ALERT SERVICE BULLETIN
Bell Helicopter **TEXTRON**

NO. 212-04-120

MODEL AFFECTED: 212

SUBJECT: TAIL ROTOR PITCH HORN ASSEMBLY
P/N 212-011-708-105, REPLACEMENT OF.

Figure 1
Correct Orientation of Pitch Horn Bushing

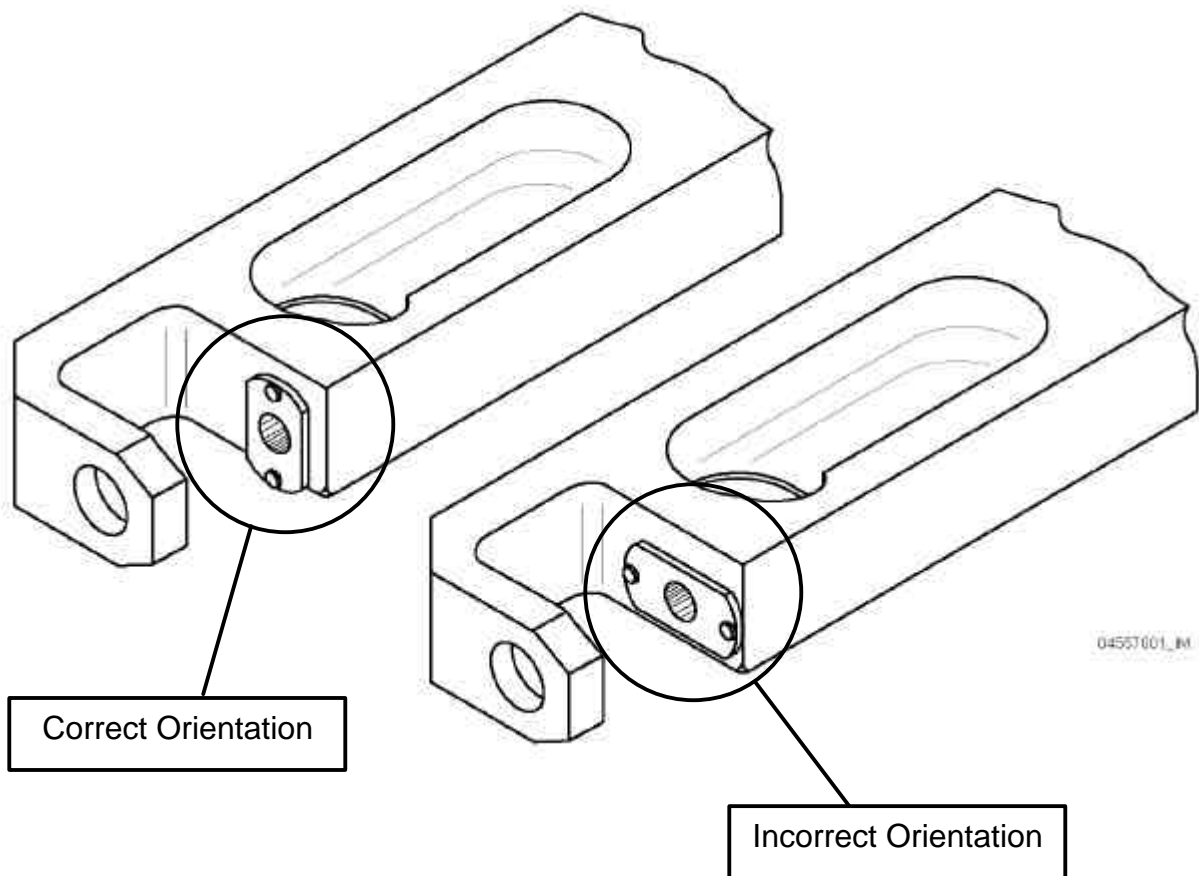
Bell Helicopter has found that subject Pitch Horns S/N TI-1 through S/N TI-113 may have incorrectly installed Bushings, which could cause the Pitch Links to contact the Bushings during Tail Rotor flapping. The resulting loads may cause excessive stress to the Pitch Horn, Pitch Link and attachment hardware between Pitch Links, Crosshead and Pitch Horn. Discrepant Pitch Horns shall be returned to Bell Helicopter, along with the mating Pitch Links and the attachment hardware. Any Pitch Horns bearing a letter "R" at the end of the affected serial number has been either reworked or found to conform, and therefore is not affected by this ASB.

1. Review historical service records and physically identify T/R pitch horn serial numbers installed on aircraft and held in spares inventory.
2. For each horn found to be within the serial number block, verify position of bushing using Figure 1. If bushing is found properly positioned, add a letter "R" at the end of the serial number, using a vibrating stylus (For example: TI-113R).

3. If bushing is found incorrectly positioned in accordance with Figure 1, remove discrepant pitch horns, mating pitch links and attaching bolts (20-057-5-14D & NAS6605H20) and return to Bell Helicopter for credit. Remove any chordwise

4. Re-assemble Tail Rotor Hub & Blade Assembly as required by replacing discrepant parts with new and/or serviceable pitch horns, pitch links and attachment hardware between pitch horn and pitch link and crosshead to pitch link. Dynamic balance as required after installation.
5. All discrepant pitch horns serial number TI-1 through TI-113 that have never seen service on an aircraft may be reworked at Bell Helicopter. Reworked pitch horns will have a letter "R" at the end of the serial number.
6. Annotate historical records to show compliance with this bulletin.
